SILVAIRE AIRCRAFT CO.

SERVICE BULLETIN #3

We have received reports of aileron cable pulleys rubbing on the fuel line in the area of the wing root leading edge and the upper end of the forward door post on the model 8F Luscombe. For the purpose of correcting this condition we recommend the following repair.

SILVAIRE AIRCRAFT COMPANY SERVICE BULLETIN #3 October 19, 1959

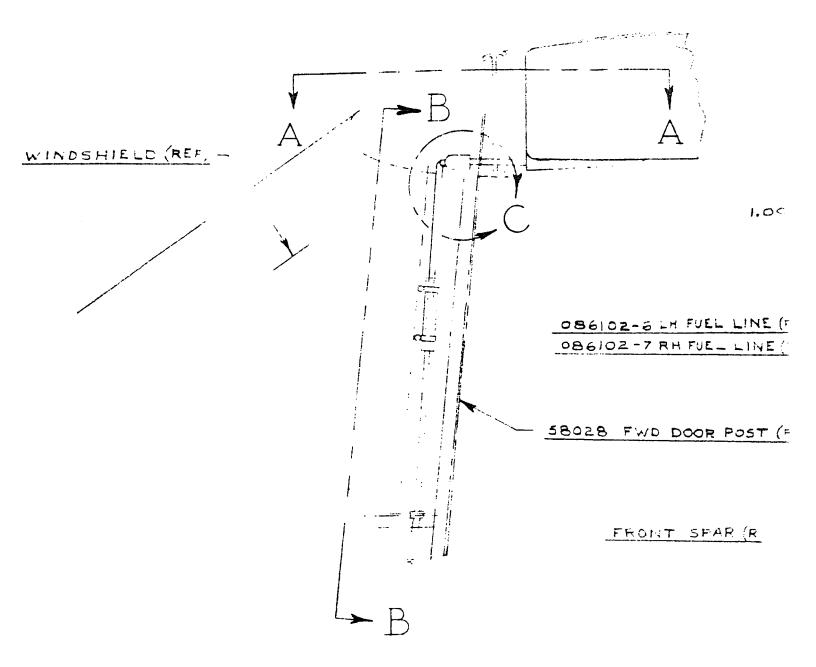
- 1. Remove 086102-6 L.H. and -7 R.H. fuel lines.
- 2. Re-form the removed tubes as shown on the attached sketch. Care should be taken to properly support the tubes during this operation.

- 3. Remove .20 inch from the lower end of the tubes.
- 4. Inspect the tubes for any damage resulting from the rework and if the condition of the tubes is unsatisfactory, replace with new tubes formed as shown on the attached sketch.

- 5. Using a rotary file trim the fuselage wing root leading edge area as shown on the attached sketch. Be careful not to trim below the .25 inch "along fairing contour" demension.

- 6. Index the fuel line elbow located in the wing root leading edge at 1.5 degrees down in relation to the spar. (see attached sketch.)
- 7. Re-install the tubes being careful to index the clamps on the connecting hose such that they do not interfere with the aileron cable.

- 8. Inspect the completed installation to be certain that the clearance between the cable pulley and the tube is at least .06 inch.

OR CALLETING THE FUEL LINE SHALL
NOT BE LESS THAN . 06

INDEX CLAN
THAT THEY D
INTERFER W
ALLERON CA
